DATE **Feb.10/03**
V2500-A1/A5/D5 SERIES PROPULSION SYSTEM SERVICE BULLETIN

This document transmits Revision 2 to Service Bulletin EV2500-72-0439

ENGINE - NO. 4 COMPARTMENT STRAINER IMPROVEMENT

Location of the No.4 Bearing Seal Support Assembly
Figure 1, Sheet 1

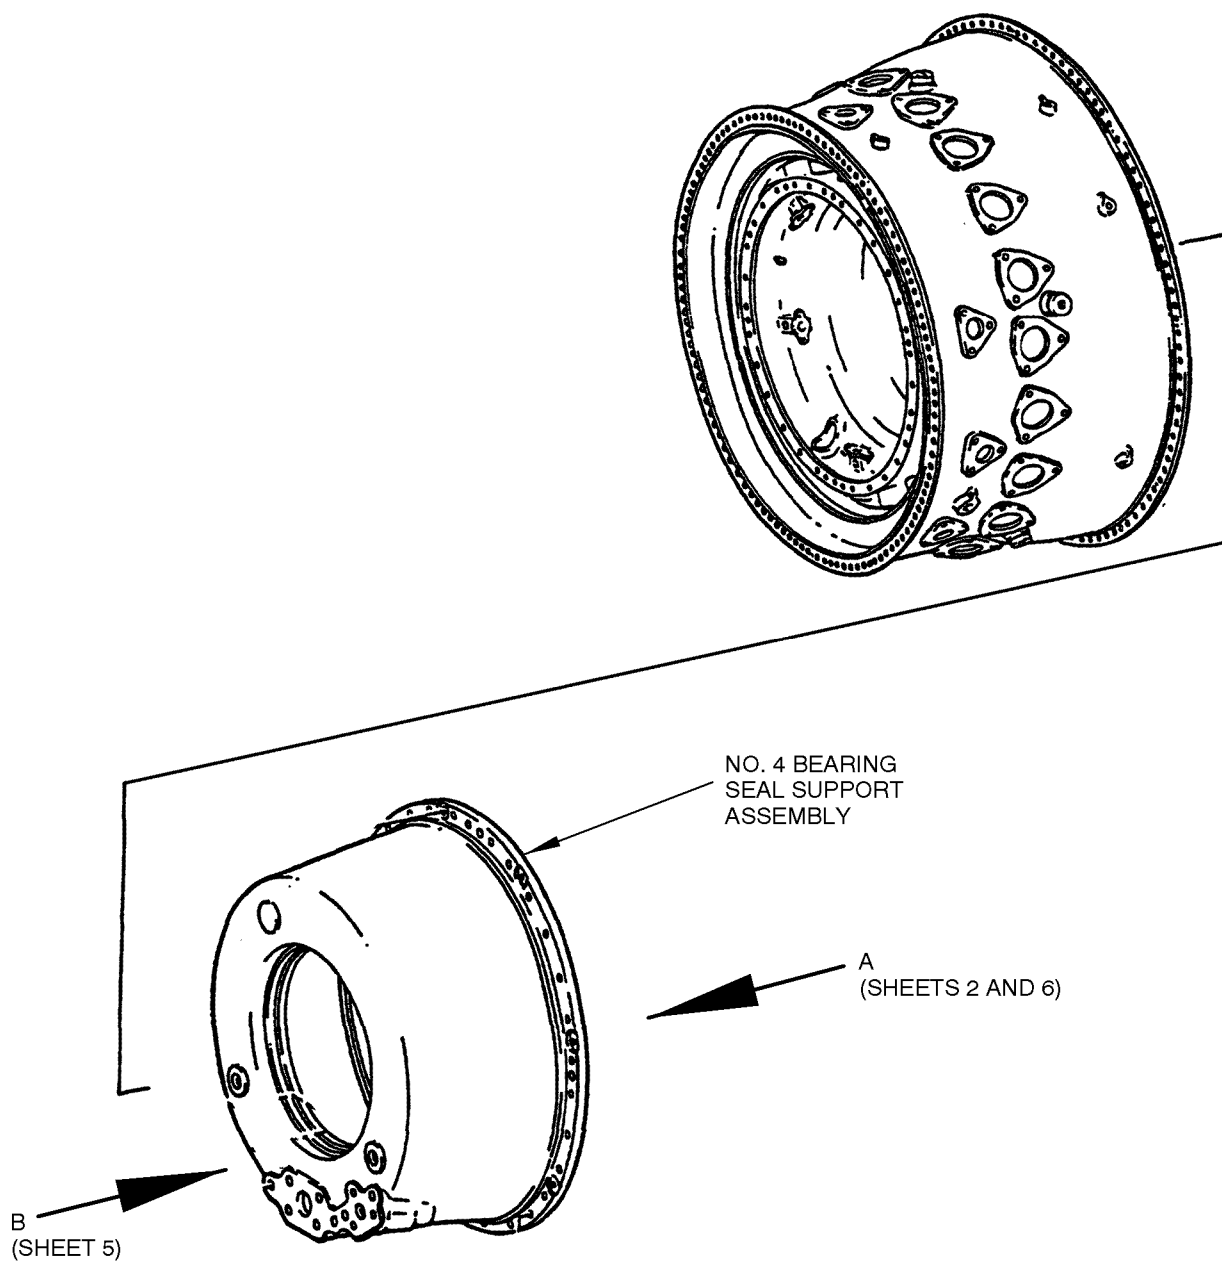
R (6) Produce and deburr 10 holes in the No. 4 bearing seal support assembly. Refer to Figure 1, Sheet 1 for the location of the assembly. Refer to Figure 1, Sheets 2, 3, 4 and 6 for the location of the 10 holes.

- R (3) Produce and deburr 10 holes in the No. 4 bearing seal support assembly.
R Refer to Figure 1, Sheet 1 for the location of the assembly. Refer to
R Figure 1, Sheets 2 thru 4 for the location of the 10 holes.

Location of the 10 Machined Holes
Figure 1, Sheet 3

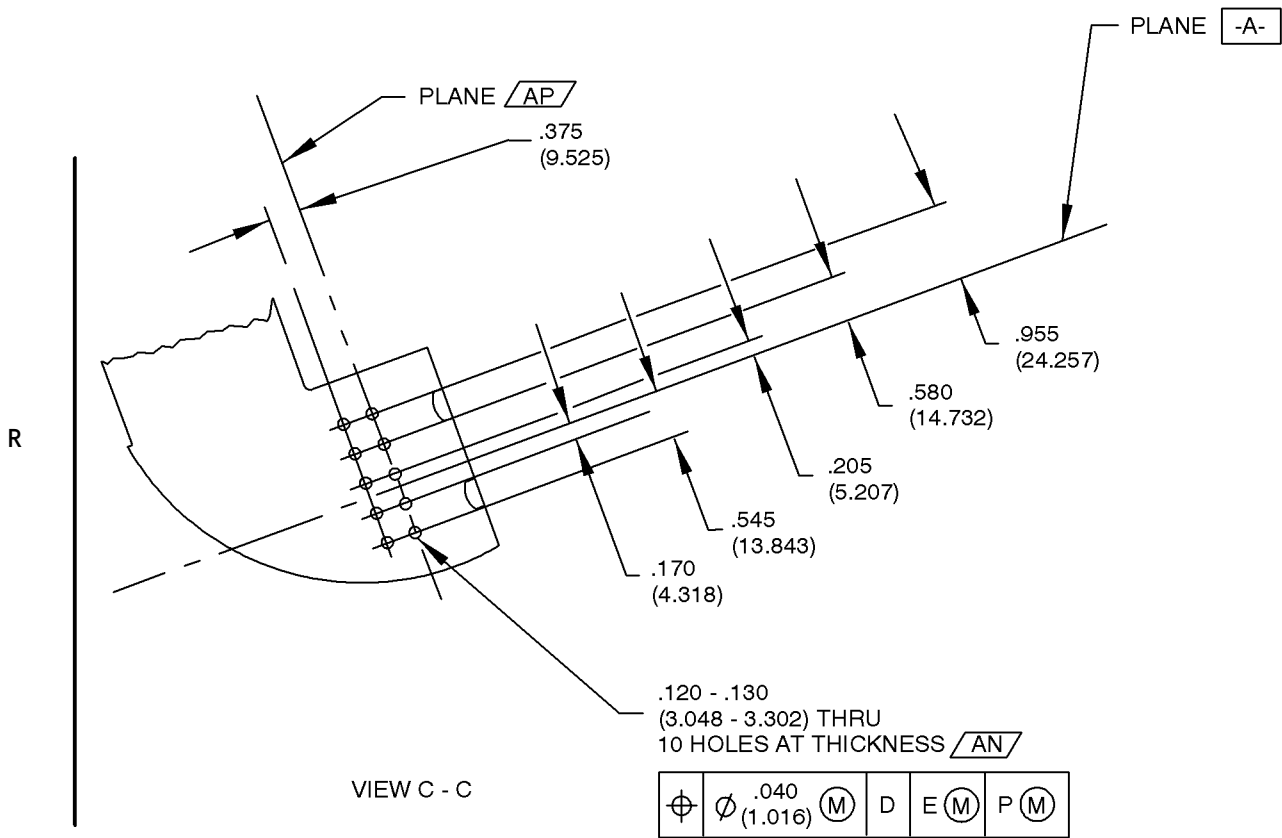
(7) Inspect the holes by Figure 1, Sheets 2, 3, 4 and 6.

- R (4) Inspect the holes by Figure 1, Sheet 3.

Identification of the Modified No.4 Bearing Seal Support Assembly
Figure 1, Sheet 5

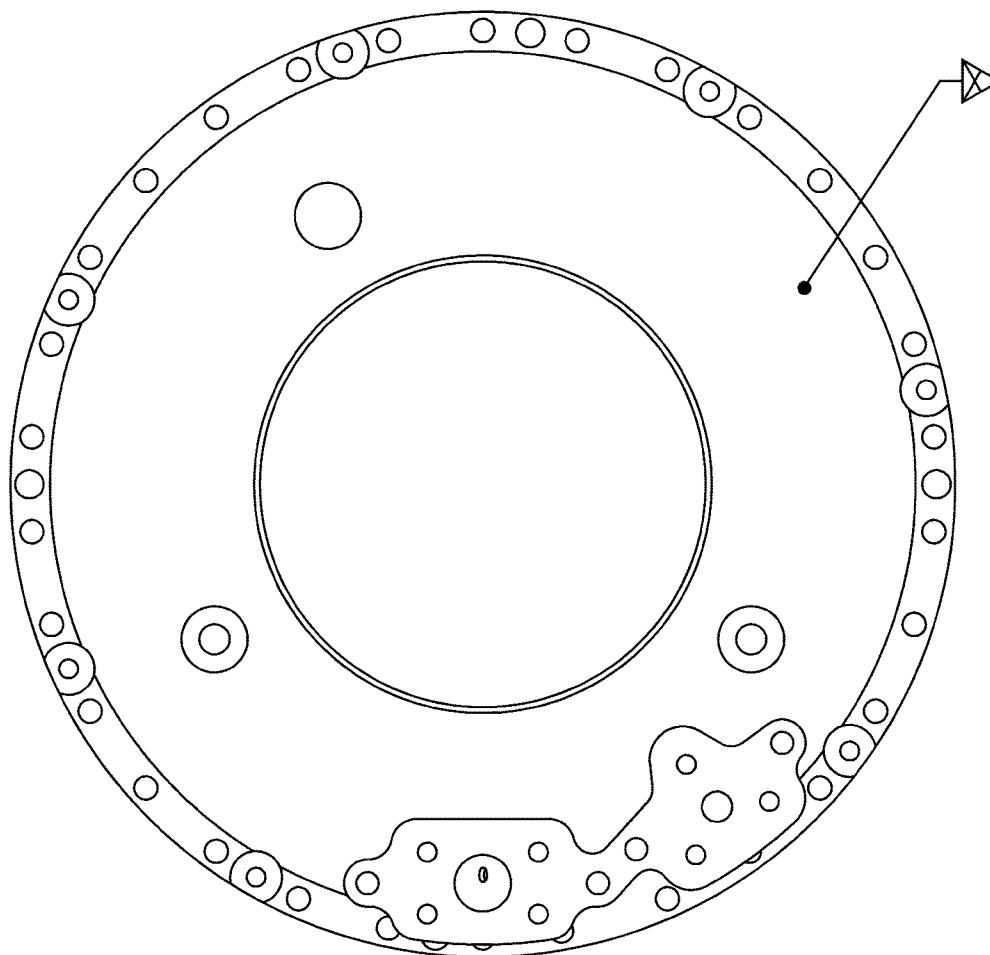
(10) Identify No. 4 Bearing Seal Support Assembly, PN 2A3537, as PN 2A3845. Refer to Figure 1, Sheet 5.

- R (7) Identify No. 4 Bearing Seal Support Assembly, PN 2A3537, as PN 2A3845.
R Refer to Figure 1, Sheet 5.

R Identification of the Modified No.4 Bearing Front Seal Assembly
R Figure 1, Sheet 6

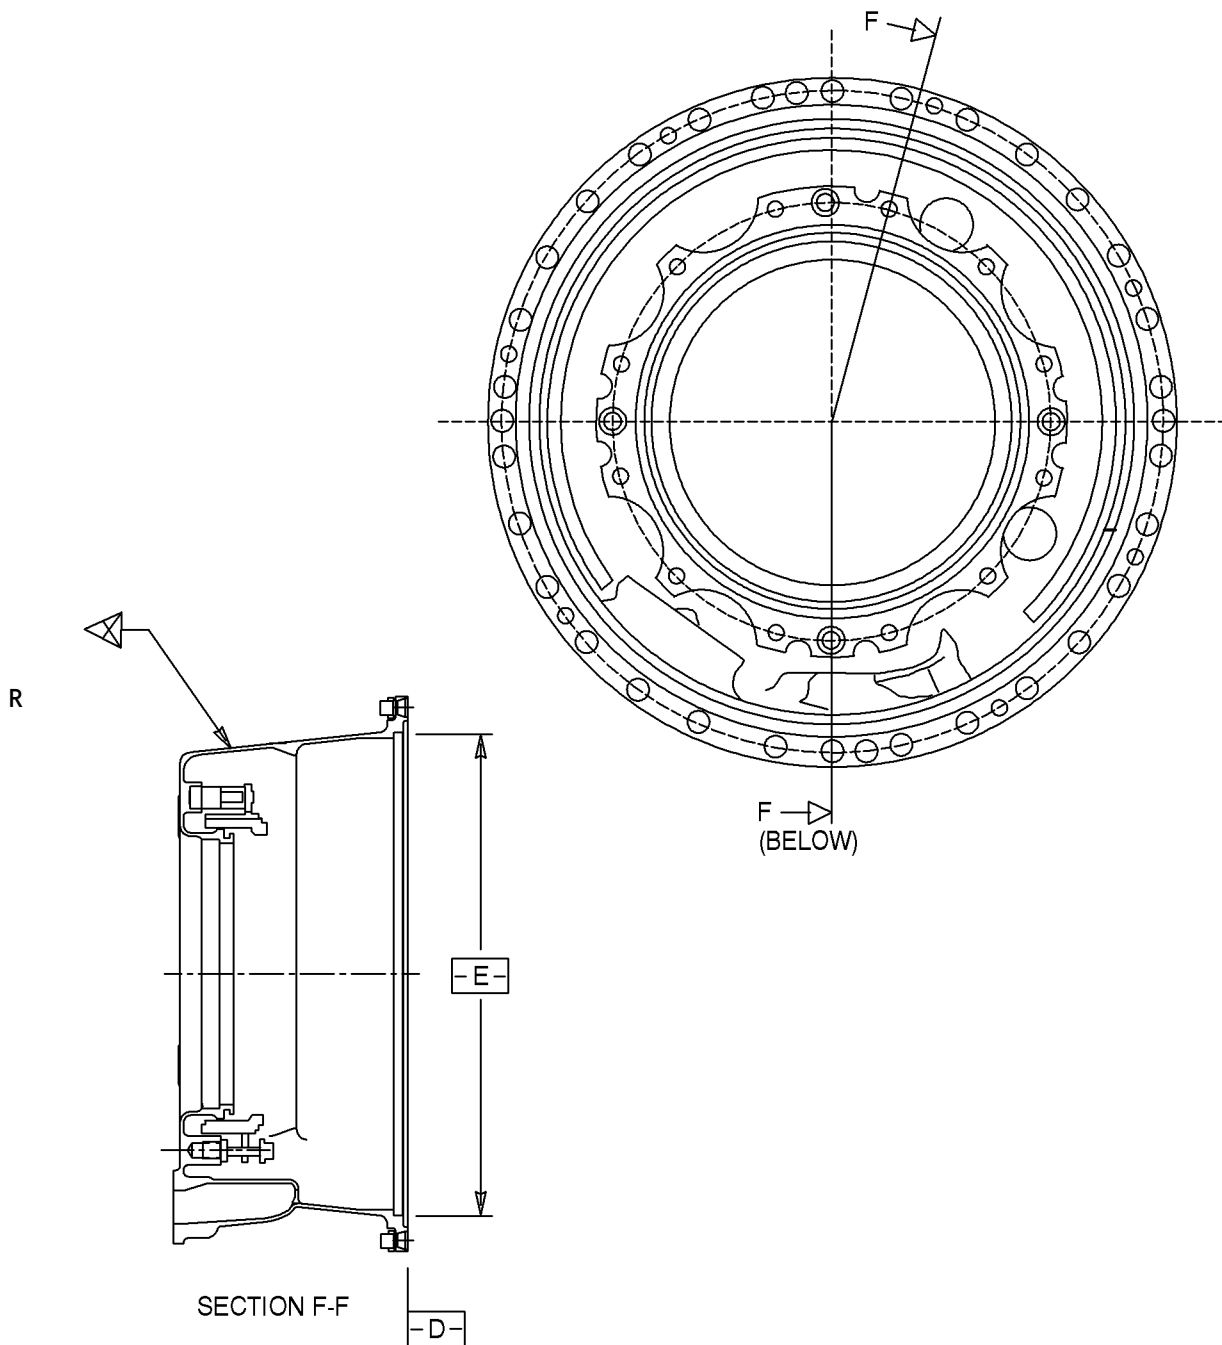
(12) Identify No. 4 Bearing Front Seal Assembly, PN 2A3538, as PN 2A3846. Refer to Figure 1, Sheet 6.

- R (9) Identify No. 4 Bearing Front Seal Assembly, PN 2A3538, as PN 2A3846. Refer
R to Figure 1, Sheet 6.
